**City of Richmond  
Department of Planning  
& Development Review**

**Location, Character, and Extent**

**LOCATION:** 50 N 17th Street

**PROPOSAL:** The application is for final location, character and extent review of the 17th Street Farmer's Market Plaza Renovation Modifications

DRAWING TITLE  
**PAVING PLAN**

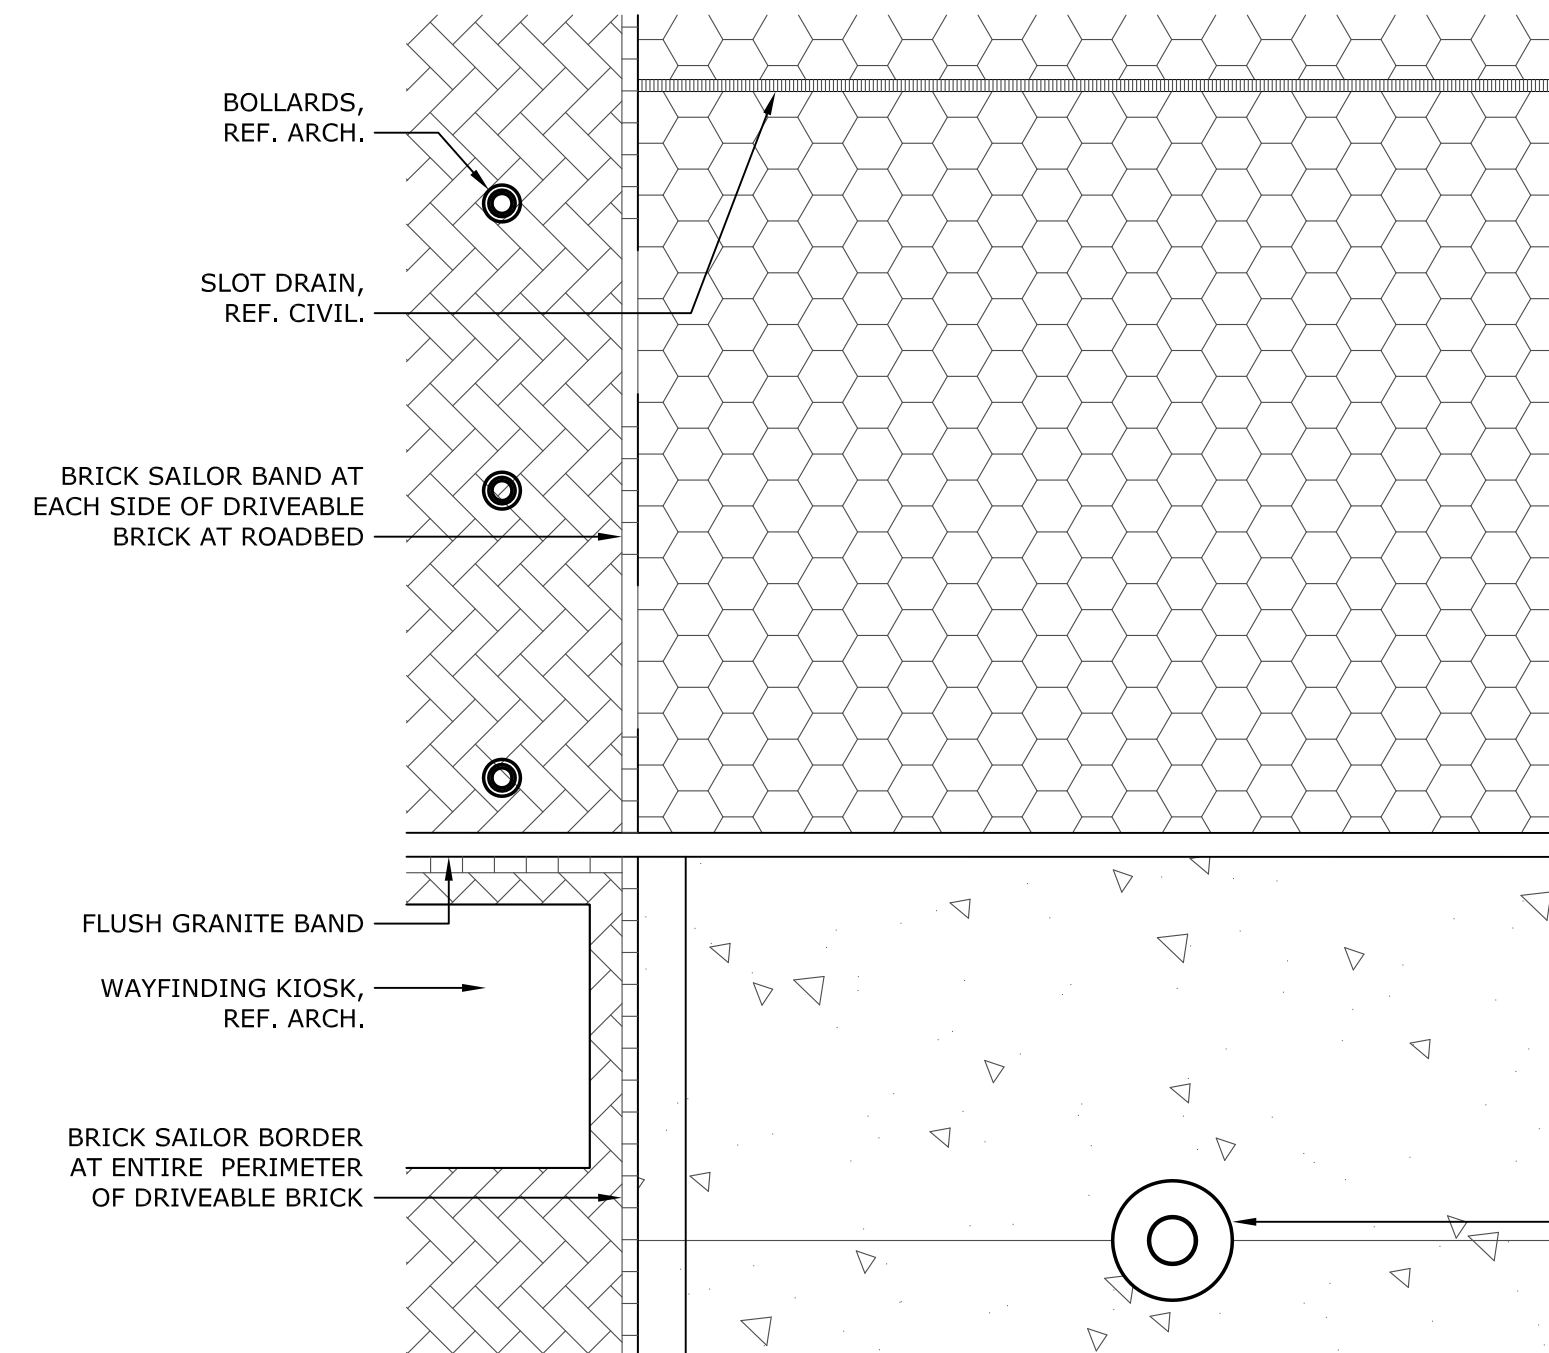
TYPICAL AREA OF SHALLOW LEAF IMPRINTS AS SHOWN IN 14/L202

MATCH ARCHING PATTERN OF MAIN FIELD TYPE F 'FISHSCALE' GRANITE SPALL AS CLOSELY AS POSSIBLE WITHOUT CUTTING SPALLS AT THIS BAND

Detail 20/A703 from 10/17/16 Permit Set

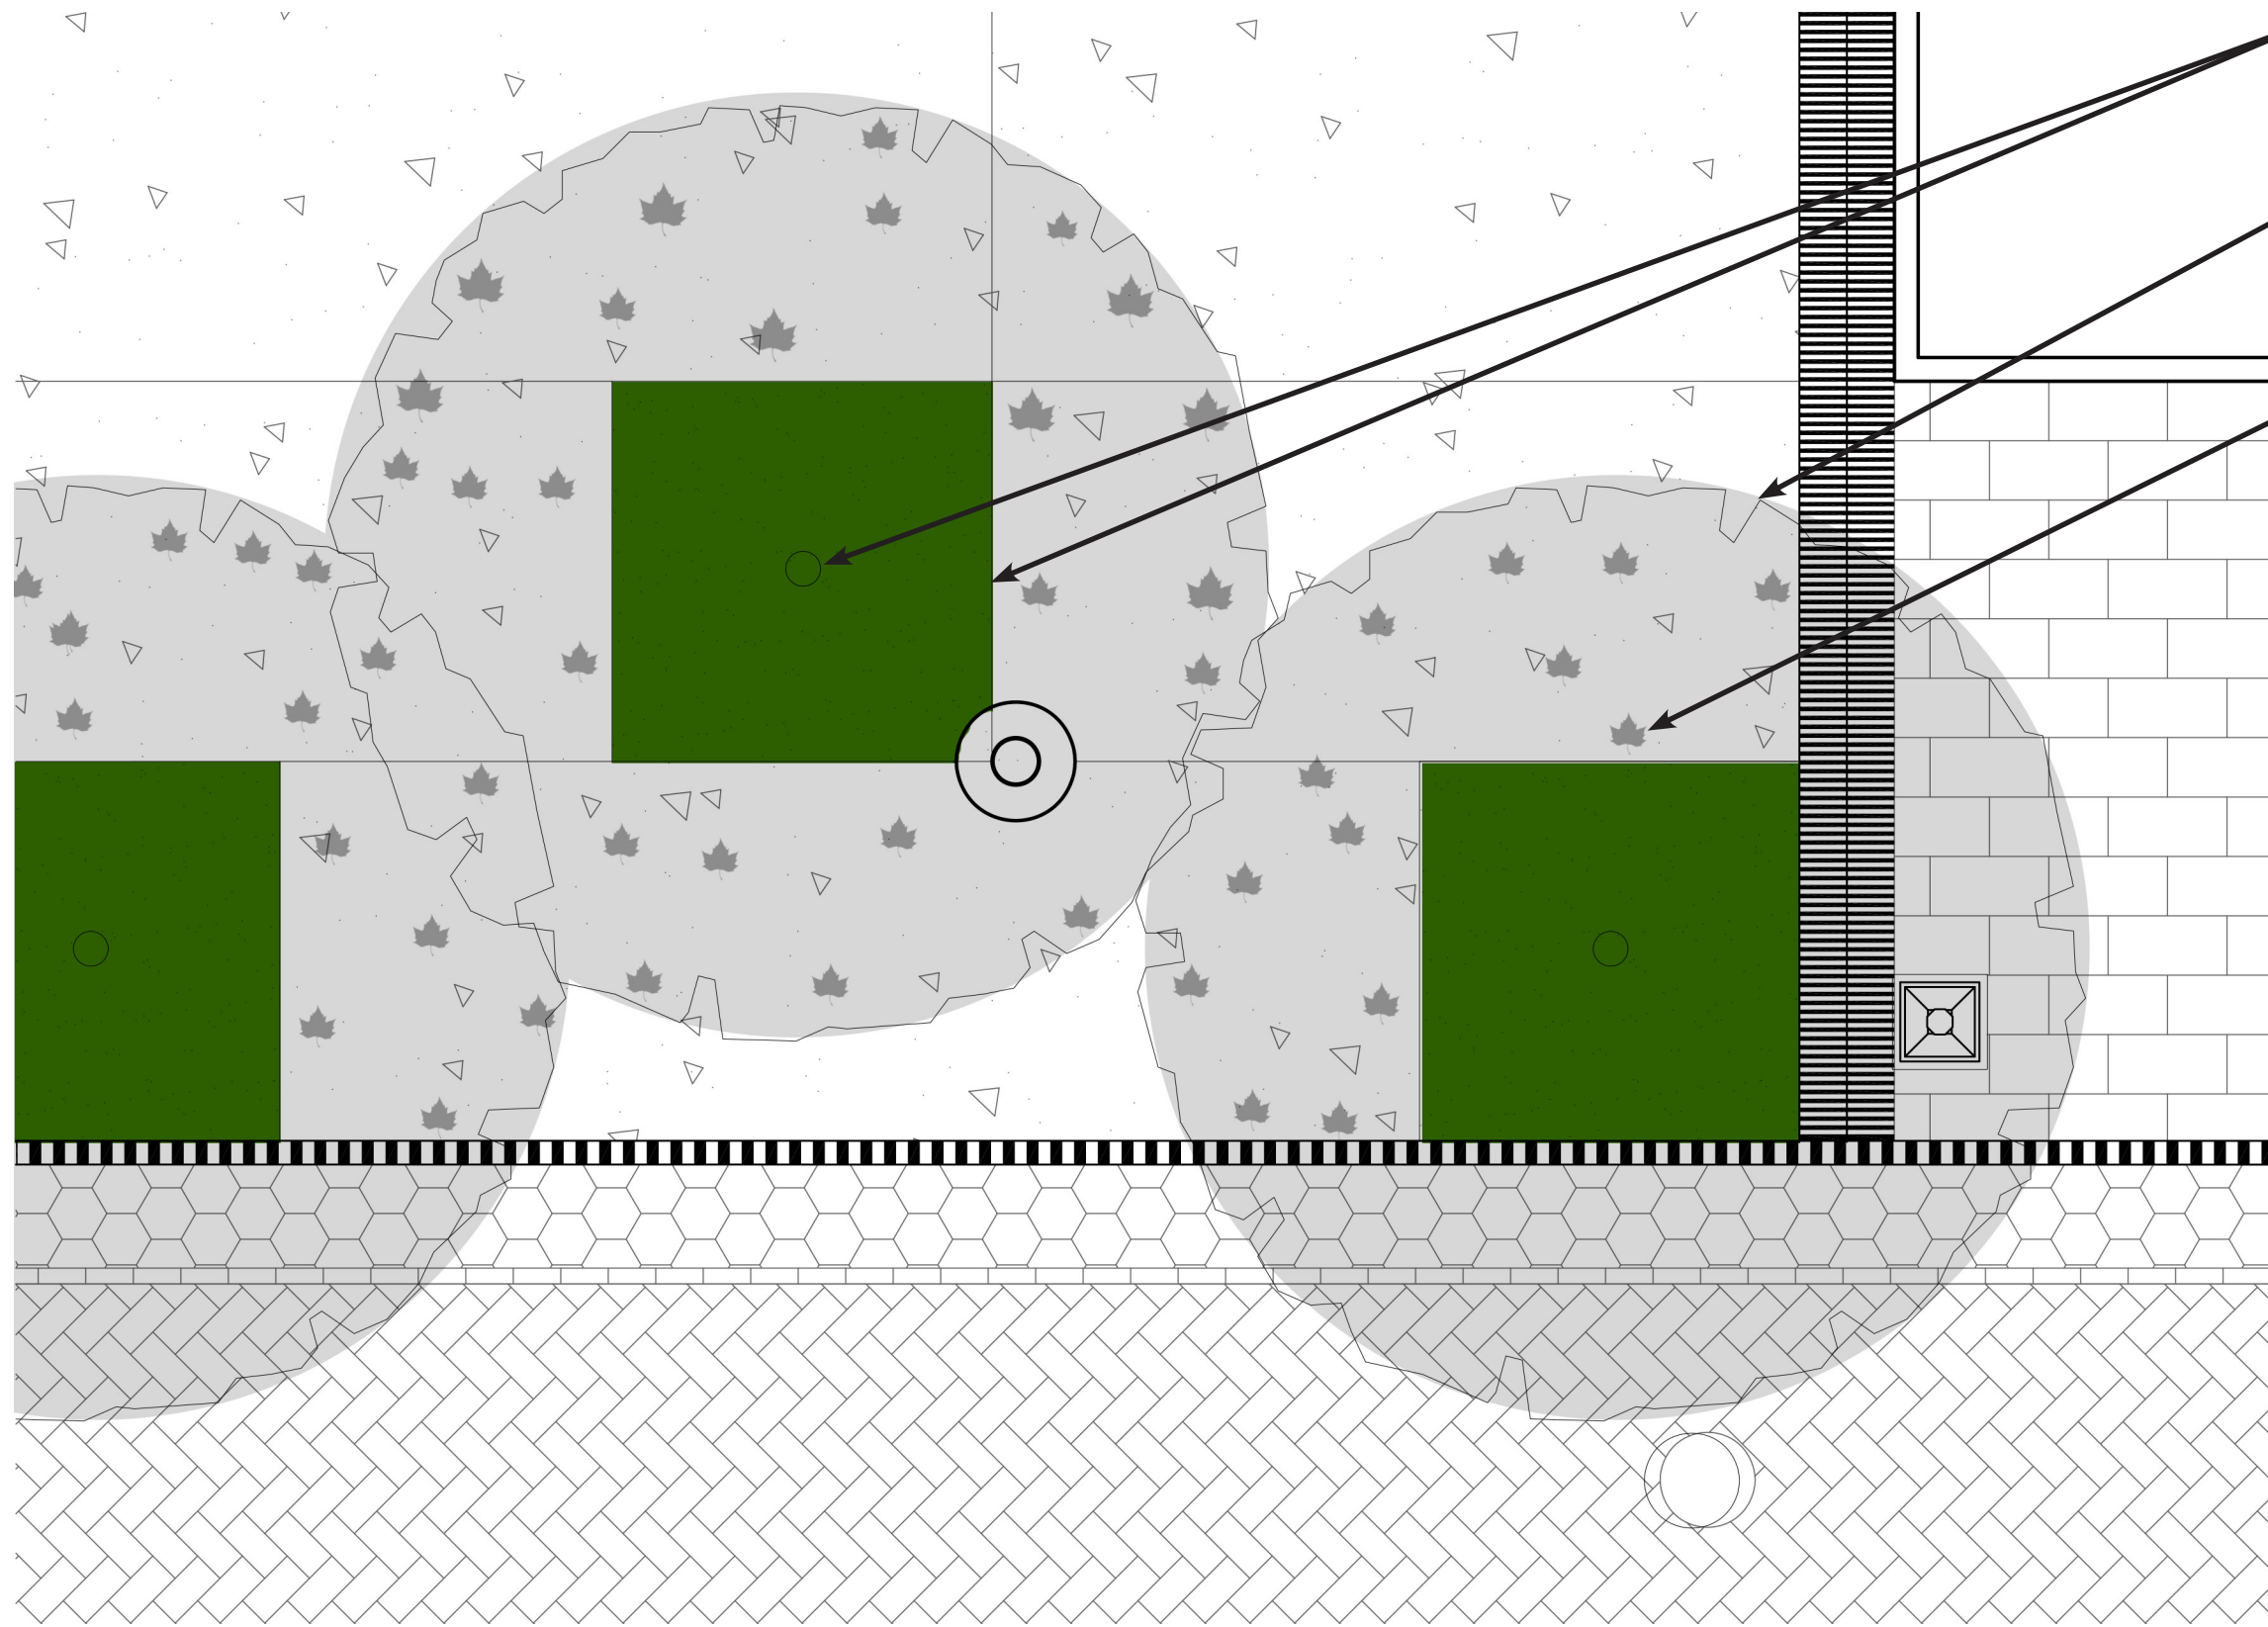
SHALLOW LEAF IMPRINTS IN  
RANDOM PATTERN BENEATH  
DRIP LINE, TYPICAL.
